PROPOSED CHANGE TO THE OPERATING LICENSE

REMOVAL OF CYCLE SPECIFIC PARAMETERS FROM TECHNICAL SPECIFICATIONS

(GGNS PCOL-92/07)

GGNS PCOL-92/07 - MARKED-UP TECHNICAL SPECIFICATION PAGES

FIGURE 3.2.1-1 MAPLHGR vs AVERAGE PLANAR EXPOSURE

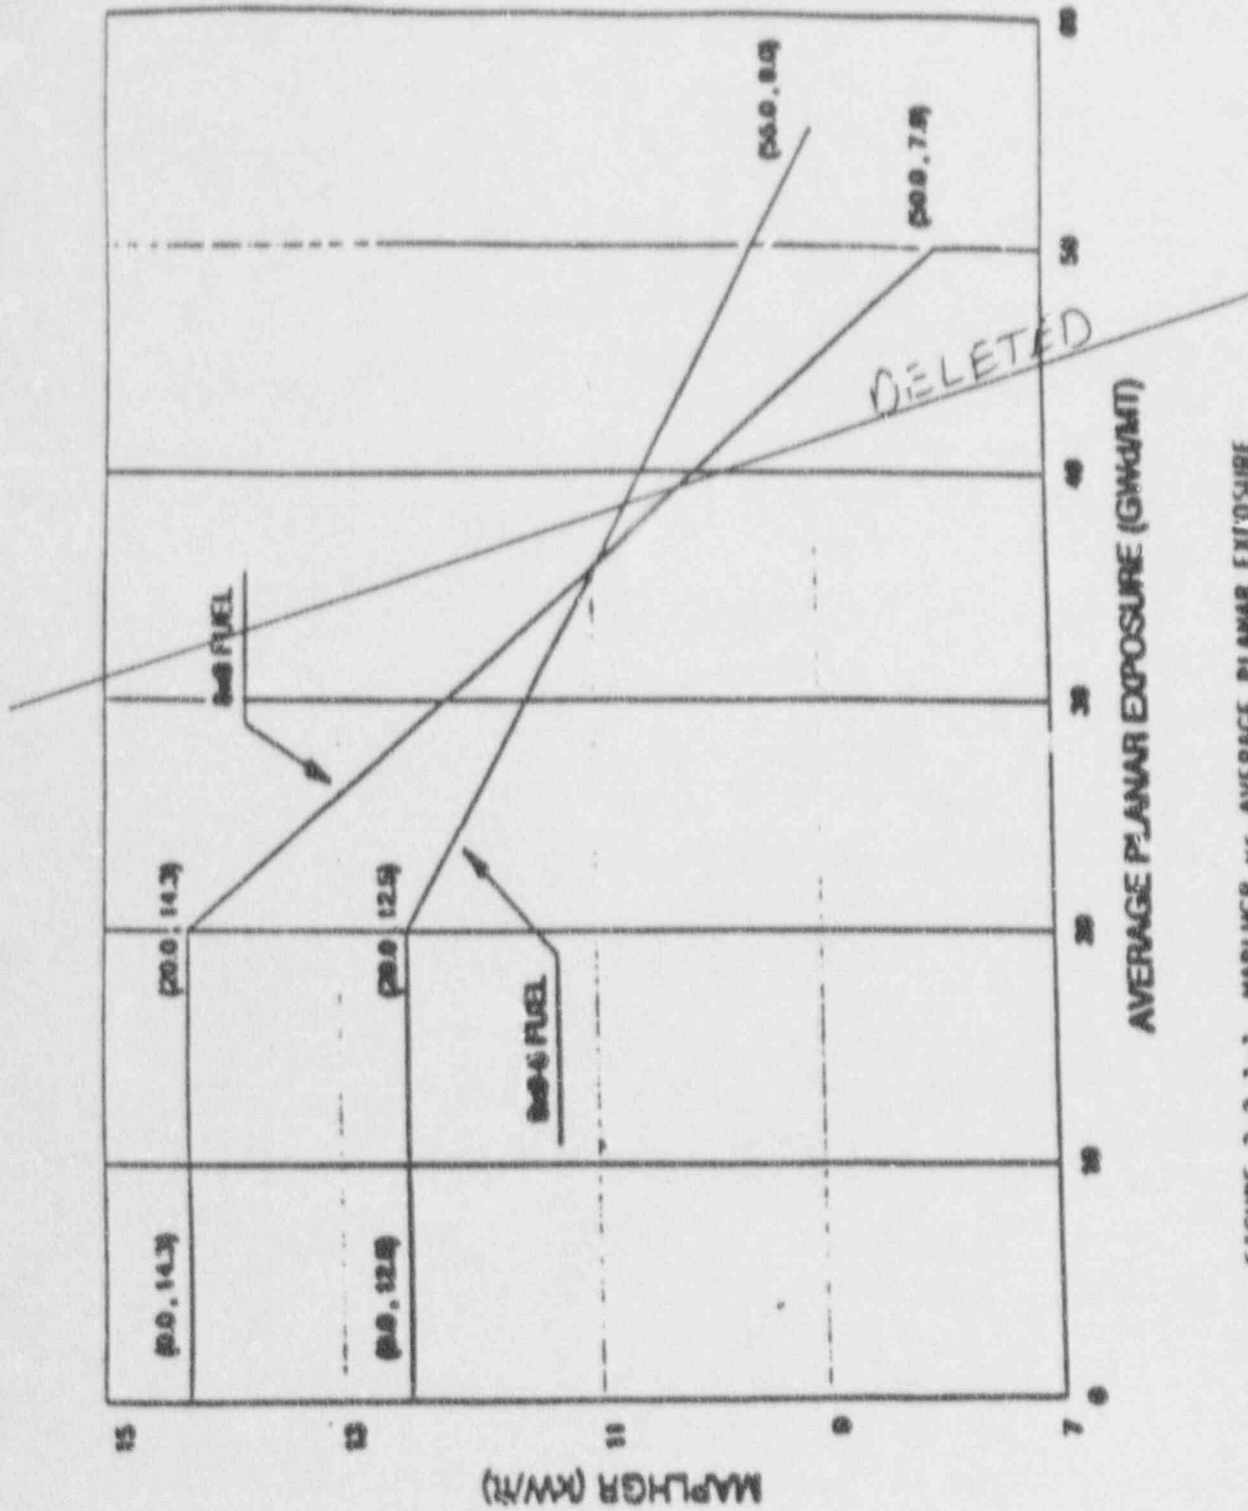
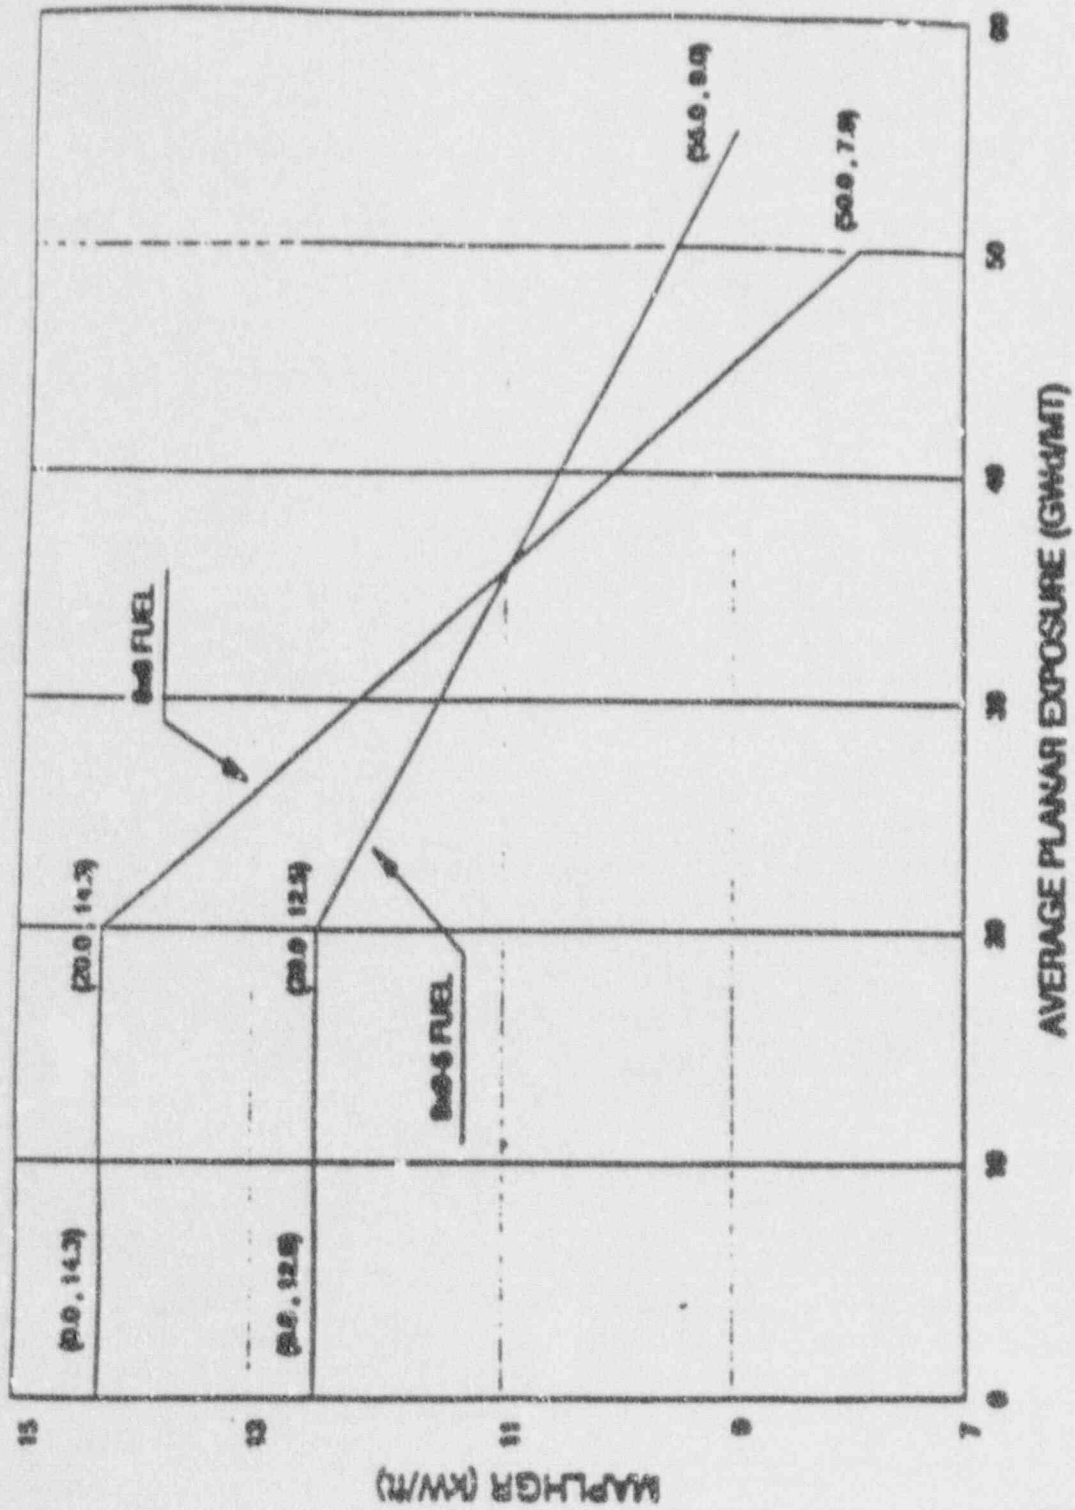
- 1) A new specification is added after 1.7 as 1.7a. Specification 1.7a provides the definition of the CORE OPERATING LIMITS REPORT (COLR).
- 2) The word "both" is deleted from specification 2.1.2. This is an editorial change.
- 3) Limiting Condition for Operation (LCO) 3.2.1 and its Action statement are reworded to reference the Core Operating Limits Report for the specific Average Planar Linear Heat Generation Rate (APLHGR) limits. Figure 3.2.1-1 is deleted.

3.2.1 ~~During two loop operation, all~~ ^A AVERAGE PLANAR LINEAR HEAT GENERATION RATES (APLHGRs) for each type of fuel as a function of AVERAGE PLANAR EXPOSURE shall not exceed the limits shown in Figure 3.2.1-1, specified in the CORE OPERATING LIMITS REPORT.

During single loop operation, the APLHGR for each type of fuel as a function of AVERAGE PLANAR EXPOSURE shall not exceed the limit shown in Figure 3.2.1-1 multiplied by 0.86. Delete

During two loop operation or single loop operation, with an APLHGR exceeding the limits of Figure 3.2.1-1 as corrected by the appropriate multiplication factor, initiate corrective action within 15 minutes and restore APLHGR to within the required limits within 2 hours or reduce THERMAL POWER to less than 25% of RATED THERMAL POWER within the next 4 hours.

3.2.1 All AVERAGE PLANAR LINEAR HEAT GENERATION RATES (APLHGRs) shall not exceed the limits specified in the CORE OPERATING LIMITS REPORT.

FIGURE 3.2.3-1 MCPRI

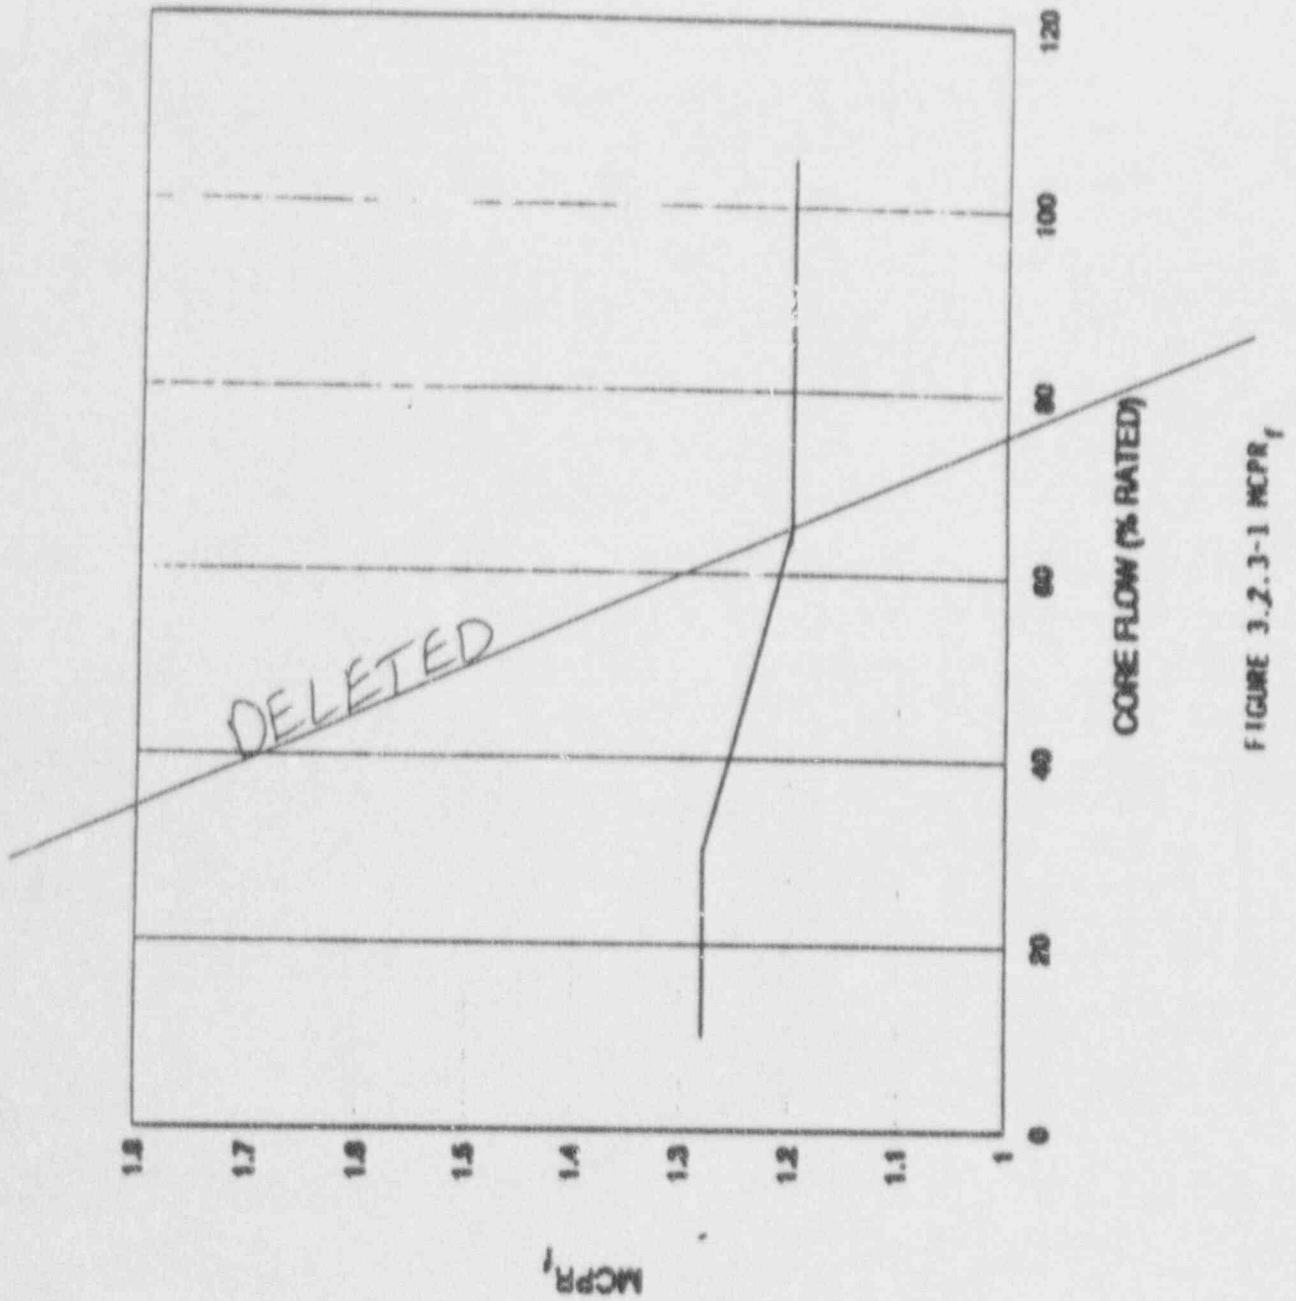
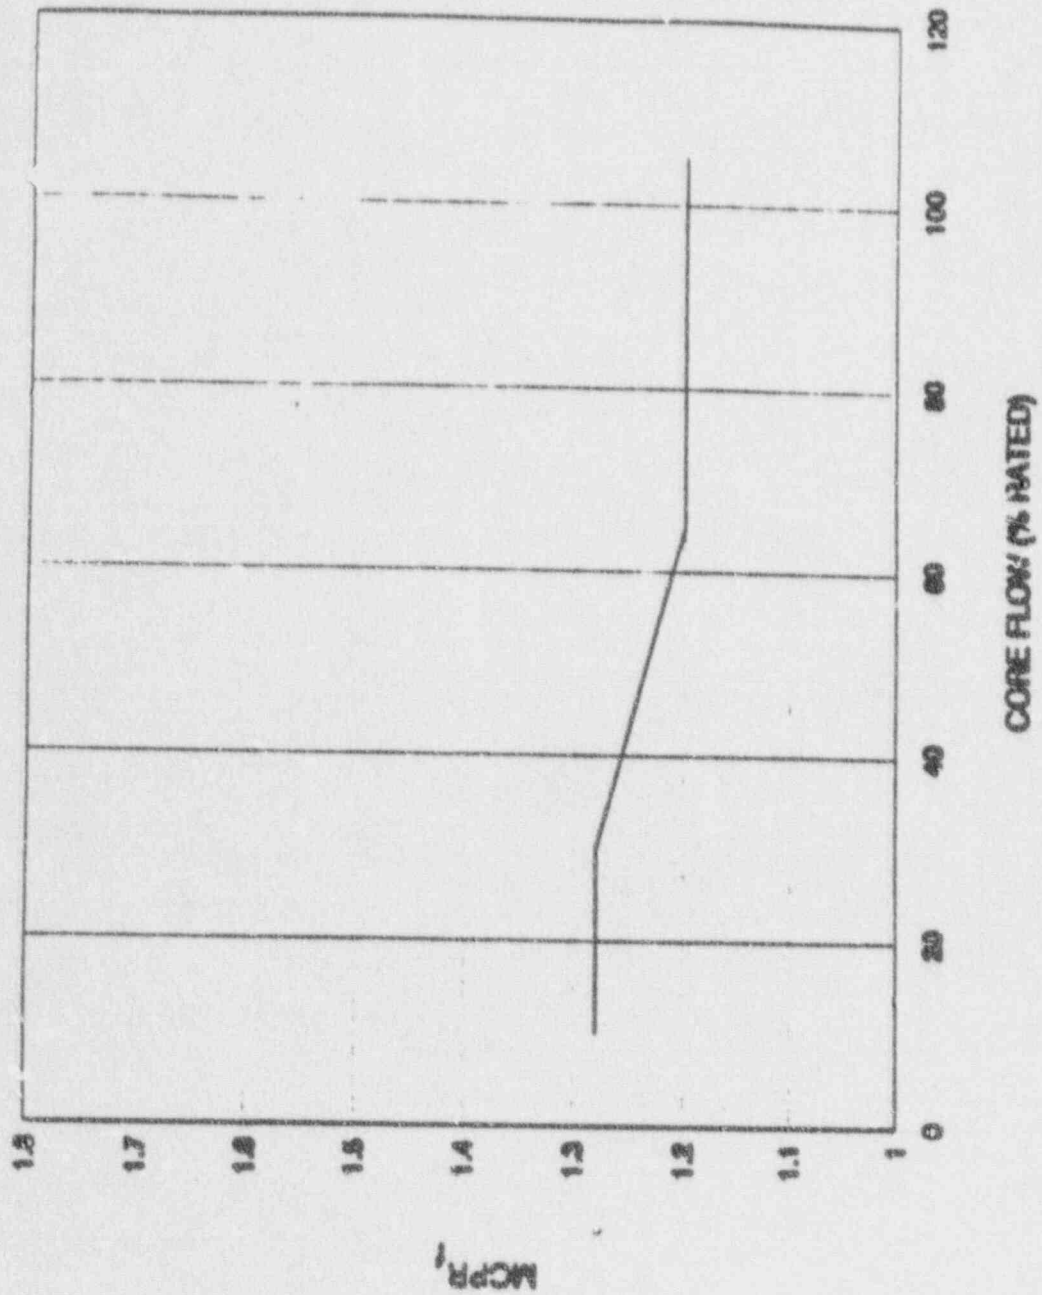
- 4) Limiting Condition for Operation (LCO) 3.2.3 and its Action statement are reworded to reference the Core Operating Limits Report for the specific Minimum Critical Power Ratio (MCPR) limits. Figures 3.2.3-1, 3.2.3-2 and 3.2.3-3 are deleted.
- 5) Limiting Condition for Operation (LCO) 3.2.4 is reworded to reference the Core Operating Limits Report for the specific Linear Heat Generation Rate (LHGR) limits. The 3.2.4 Action statement is revised to delete the source of the limits. Figures 3.2.4-1, 3.2.4-2 and 3.2.4-3 are deleted.
- 6) Section 3/4.2 page numbers and the index are revised to be consistent with the number of pages needed to contain specifications 3/4.2.1, 3/4.2.2, 3/4.2.3 and 3/4.2.4 as follows. This is an editorial change.

3.2.3 The MINIMUM CRITICAL POWER RATIO (MCPR) shall be equal to or greater than the MCPR, ~~MCPR, or MCPR~~ limits at indicated core flow, THERMAL POWER, and exposure, as shown in ~~Figures 3.2.3-1, 3.2.3-2, and 3.2.3-3.~~ ←

With MCPR less than the applicable MCPR limits ~~determined from Figures 3.2.3-1, 3.2.3-2, and 3.2.3-3,~~ initiate corrective action within 15 minutes and restore MCPR to within the required limits within 2 hours or reduce THERMAL POWER to less than 25% of RATED THERMAL POWER within the next 4 hours.

4.2.3 MCPR shall be determined to be equal to or greater than the applicable MCPR limits, ~~determined from Figures 3.2.3-1, 3.2.3-2, and 3.2.3-3.~~

specified in the CORE OPERATING LIMITS REPORT.

FIGURE 3.2.4-1 LHM vs AVERAGE PLUMAR EXPOSURE

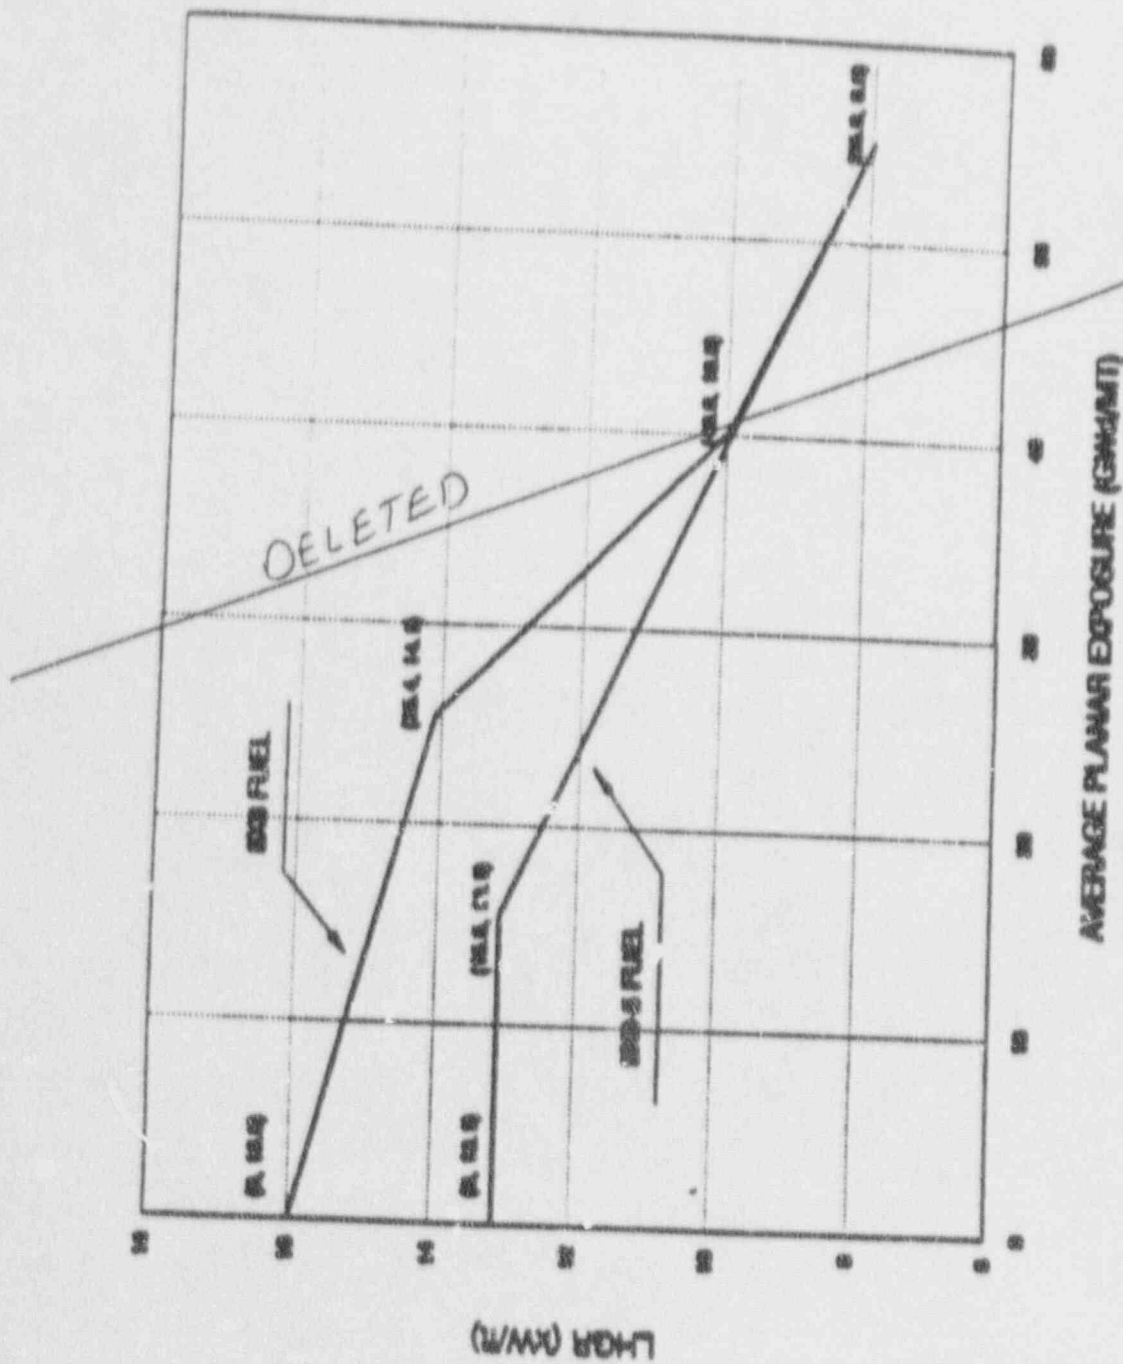
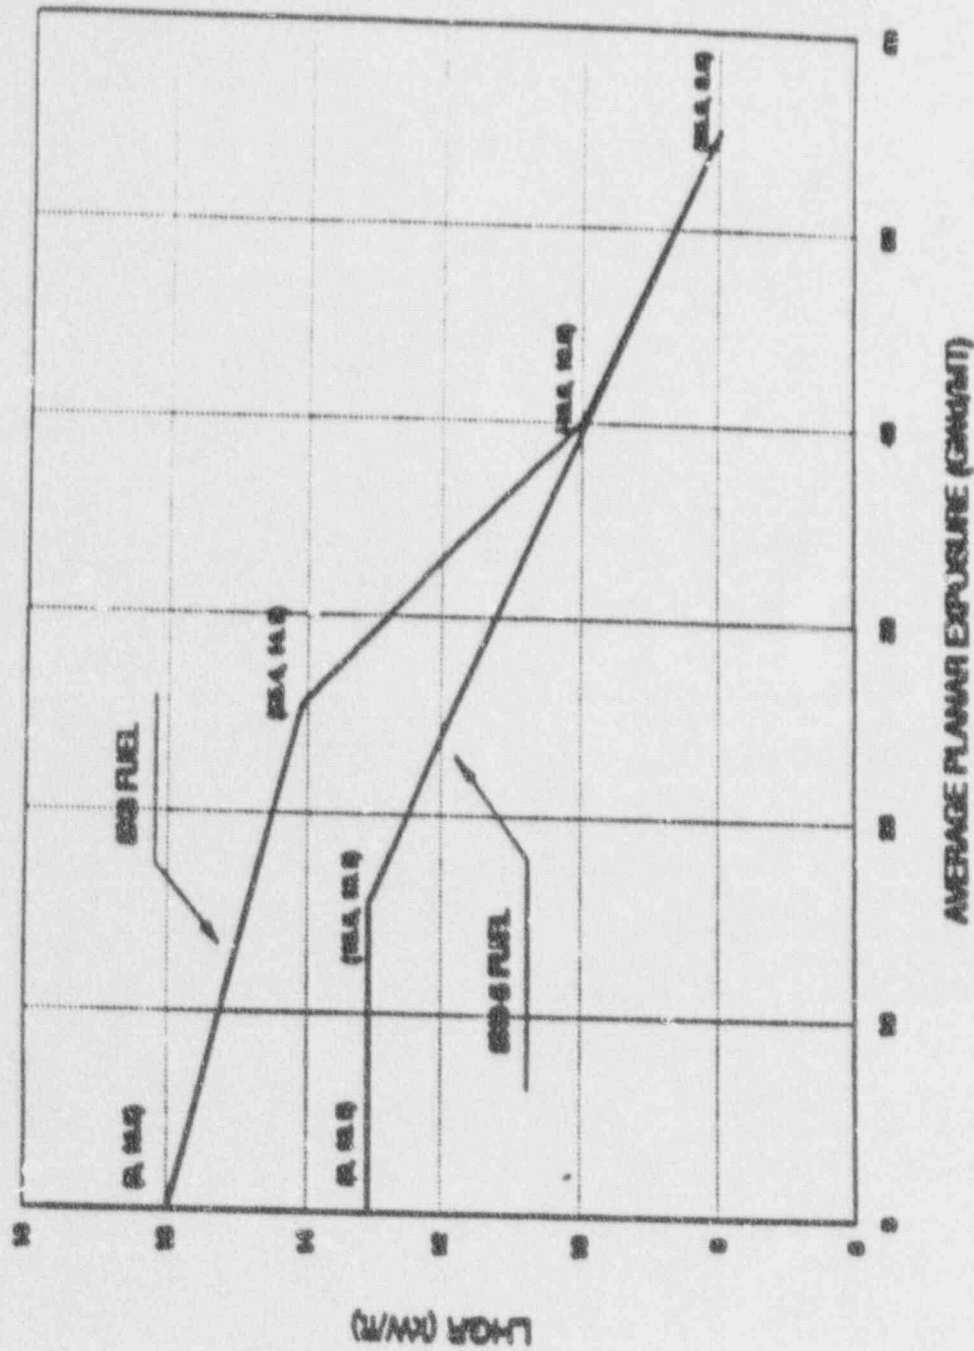
3.2.4 The LINEAR HEAT GENERATION RATE (LHGR) shall not exceed the limits specified in Figure 3.2.4-1 as multiplied by the smaller of either the flow-dependent LHGR factor (LHGRFAC_f) of Figure 3.2.4-2, or the power-dependent LHGR factor (LHGRFAC_p) of Figure 3.2.4-3, specified in the CORE OPERATING LIMITS REPORT. DELETE

With the LHGR of any fuel rod exceeding the limit of Figure 3.2.4-1, as corrected by the appropriate multiplication factor, initiate corrective action within 15 minutes and restore the LHGR to within the limit within 2 hours or reduce THERMAL POWER to less than 25% of RATED THERMAL POWER within the next 4 hours.

The LHGR limits of ~~figure 3.2.4-1~~ are multiplied by the smaller of either the flow dependent LHGR factor ($LHGRFAC_f$) or the power dependent LHGR factor ($LHGRFAC_p$) corresponding to the existing core flow and power state to ensure adherence to the fuel mechanical design bases during the limiting transient. $LHGRFAC_f$'s are generated to protect the core from slow flow runout transients. A curve is provided based on the maximum credible flow runout transient for Loop Manual operation. The result of a single failure or single operator error during operation in Loop Manual is the runout of only one loop because both recirculation loops are under independent control. $LHGRFAC_p$'s are generated to protect the core from plant transients other than core flow increases.
